# Subject: WATTS BAR NUCLEAR PLANT (WBN) UNIT 2 - FINAL SAFETY ANALYSIS REPORT (FSAR) - RESPONSE TO CHAPTERS 11 AND 12 REQUEST FOR ADDITIONAL INFORMATION

The purpose of this letter is to respond to a number of requests for additional information (RAIs) regarding the Unit 2 FSAR Chapters 11 and 12.

### Watts Bar Nuclear Plant Response to Chapters 11 and 12 Requests for Additional Information

# Table 11.3-8 Data On Points of Interest Near Watts Bar Nuclear Plant (Page 1 of 2)

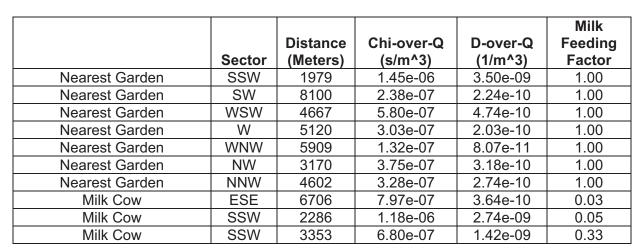
The response to RAI 11-4, and the revisions to Table 11.3-8 (Amendment 100) are inconsistent with the text in the FSAR and the FSEIS. Section 11.3.10.1 indicates that the doses are based on the 1994 land-use survey and that a cow feeding factor of 70% was used. In addition, FSEIS Table 3-21 indicates that a cow feeding factor of 0.65 was used to evaluate the iodine/particulate maximum organ dose value. Resolve these conflicts.

# Provide a justification for each of the cow feeding factors listed in Table 11.3-8.

# Describe how the revised (Amendment 100) terrain factors in Table 11.3-8 were determined.

No. 15 - New Data for Table 11.3.8
